From: Sent: To: Cc: Subject: Lasley, Timothy G Thursday, June 21, 2018 3:59 PM 'landrysco@gpdgroup.com' Werner, Jeffrey B; Mess, Camie BAR Actions - June 19, 2018 - 853 West Main Street

BAR 18-06-08 853 West Main Street Tax Parcel 31-169, 31-170 Potbelly Sandwich Shop, Owner/ Landmark Properties, Applicant/ GPD Group New outdoor café, new storefront louver, Seasonal patio cover and heaters

CITY OF CHARLOTTESVILLE BOARD OF ARCHITECTURAL REVIEW STAFF REPORT June 19, 2018

Certificate of Appropriateness Application BAR 18-06-08 853 West Main Street Tax Parcel 31-169, 31-170 Owner: Landmark Properties Applicant: GPD Group, Potbelly Sandwich Shop New outdoor café, new storefront louver, Seasonal patio cover and heaters

SOURCE: EAST COAST CHAIR SUE: 24 * 30°; 30° × 30° FINISH: BLACK POWDER COAT/POLY LUMBER	<image/>	<image/>	
PATIO TABLE TOP PATIO TABLE BASE		<section-header>PATIO CHAIR</section-header>	WASTE R
LOUVER SAMPLE (COLOR SHOWN IS NOT	AUTUAL SELEUTIUN)	PORTABLE PATIO HEATER

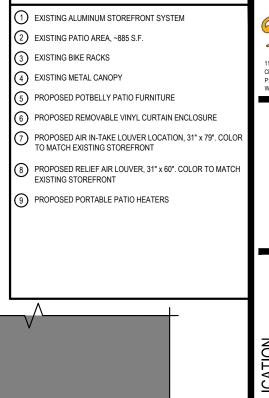
Staff finds that the remaining furniture, including patio table base and waste receptacle, to be appropriate given the City's design guidelines.

Proposed vinyl curtain: Staff recommends discussion with applicant relative to:

- the installation and visibility of necessary hardware
- periods of use (seasonal, weather-related, etc.)
- removal when not in use

The BAR moved to accept the applicant's request for deferral on the proposed seasonal patio cover [vinyl curtain].

A0.2

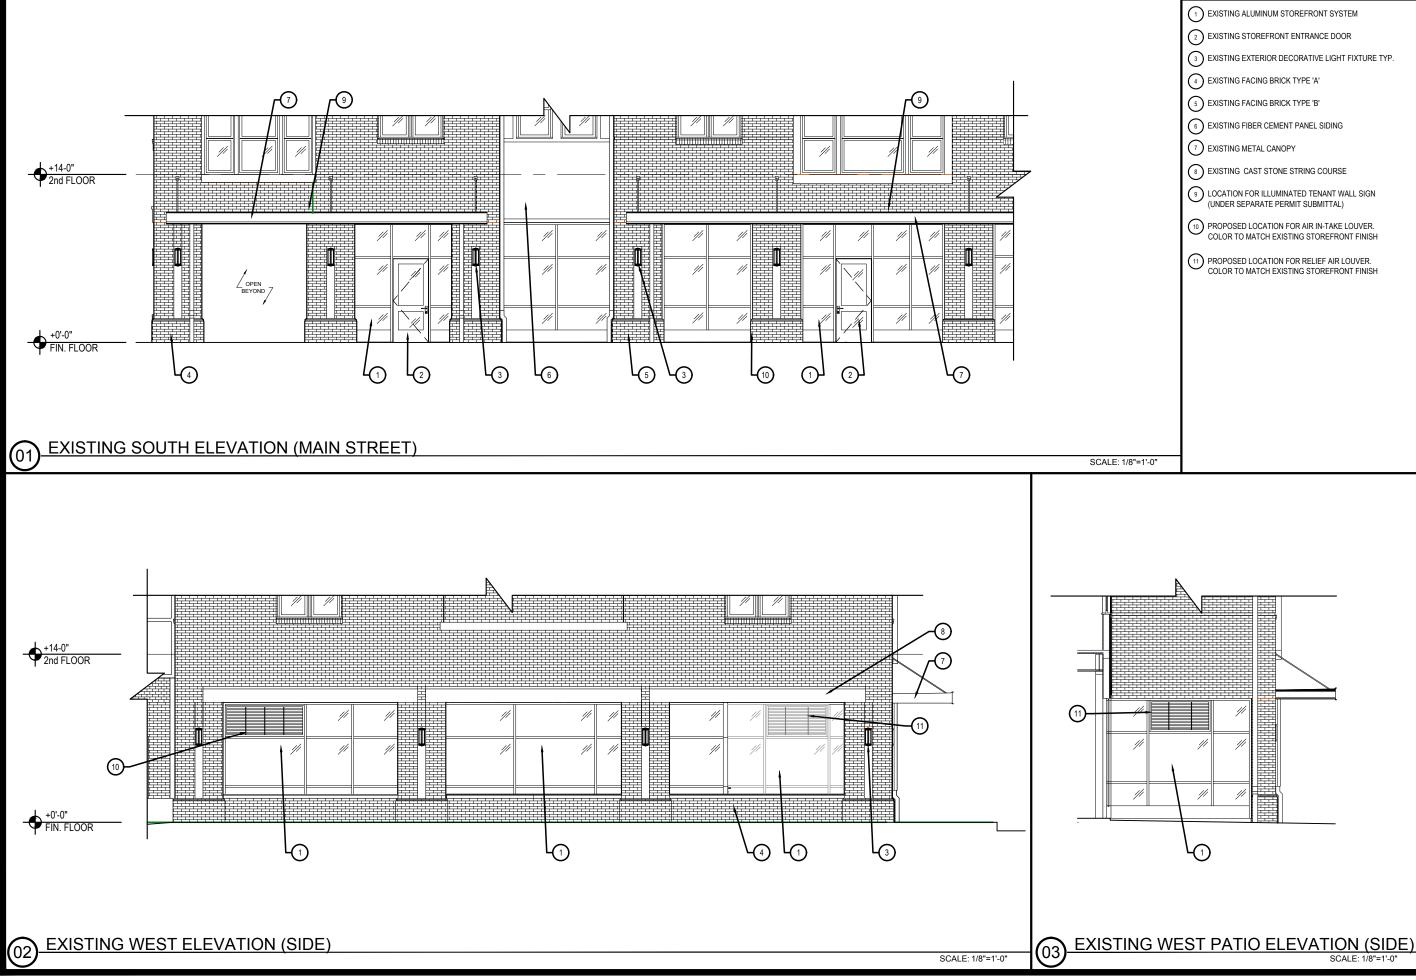
Note applicant is replacing approved window panel with louver, located on west elevation.

- The use of portable patio heaters in regard to the their location underneath the Standard
- The replacement of window panels for aluminum window louvers.
